Supplement for comments #1,2,3

IEEE 802.3 interim sessions, Phoenix, AZ, USA, January, 2013

Minimum channel insertion loss for PX40

Minimum channel insertion loss for PRX40

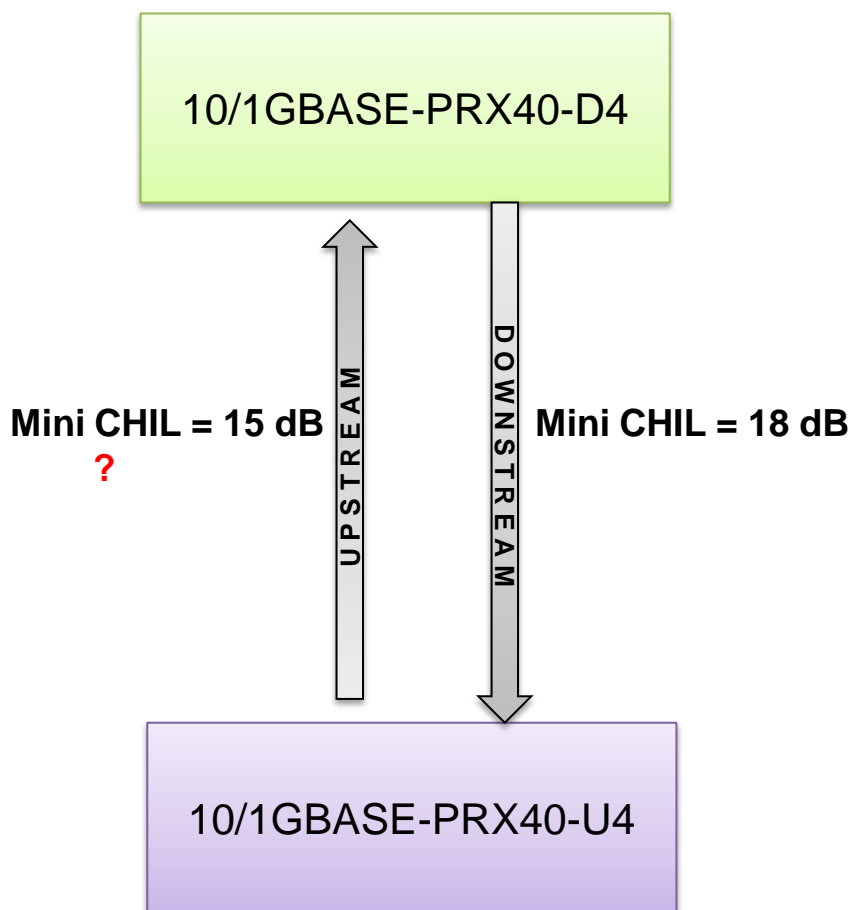
- Table 75-1 in P802.3bk D2.0,
 - Which is defined the minimum channel insertion loss for PRX40 as 18dB.
- In P802.3bk, the upstream of PRX40 is defined the same as the upstream PX40,
 - Which is showed in Table 75-7 and Table 75-9
- But the mini CHIL for PX40 Upstream is $7 - (-8) = 15$ dB, it is the same as PRX40 upstream, it will not match the requirement in Table 75-1.

The proposal new parameters for PX40/PRX40 US

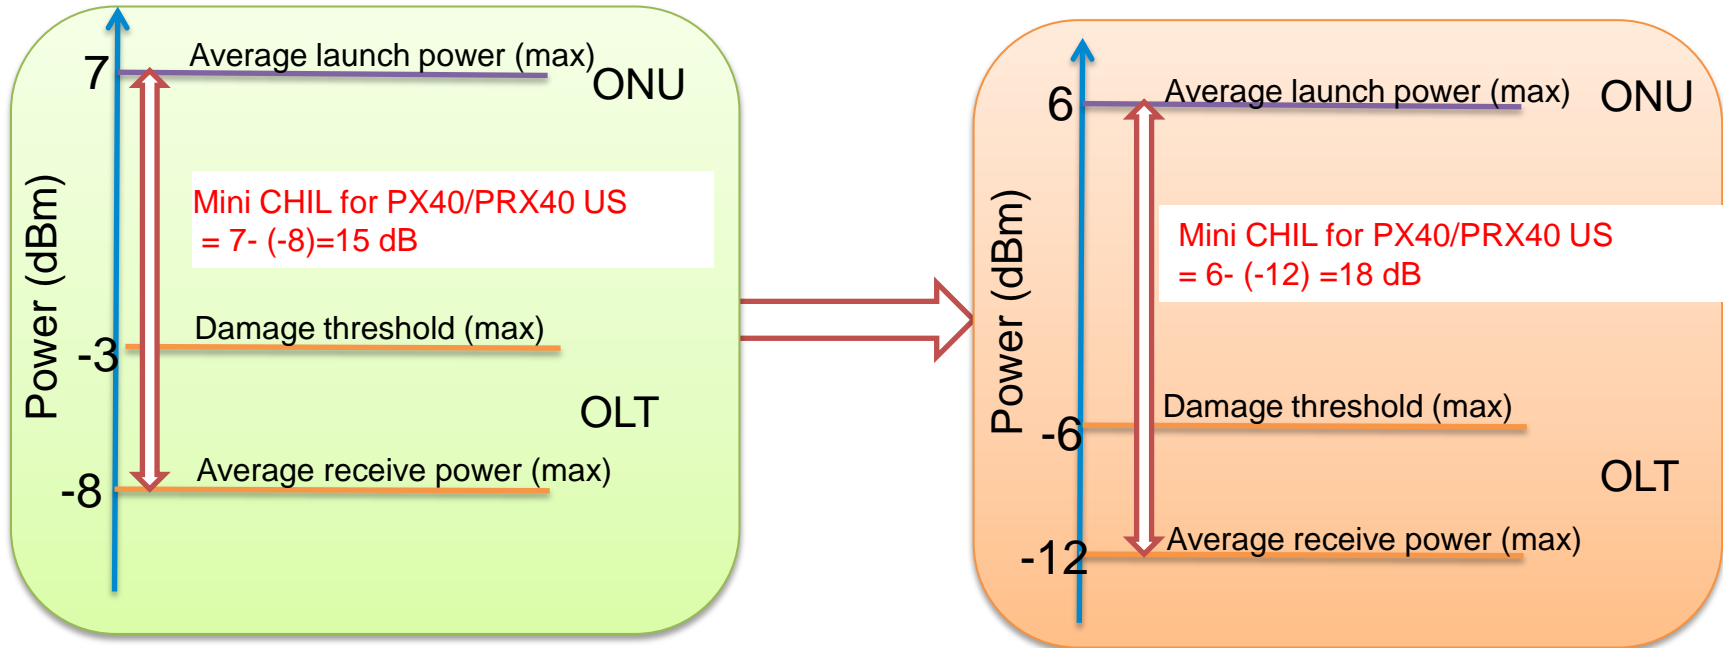
- According to the minimum channel insertion loss for PX40 as 18 dB. so we suggest to change US parameter of PX40 in Table 60-8e.
- at OLT side: (Rx) average receive power(max) from -8 dBm to -12 dBm
- Damage threshold (max) from -3 dBm to -6 dBm
- at ONU side: (Tx): Average launch power(max) from 7 dBm to 6 dBm
- Then the mini CHIL for PX40 US = $6 - (-12) = 18$ dB is satisfied.
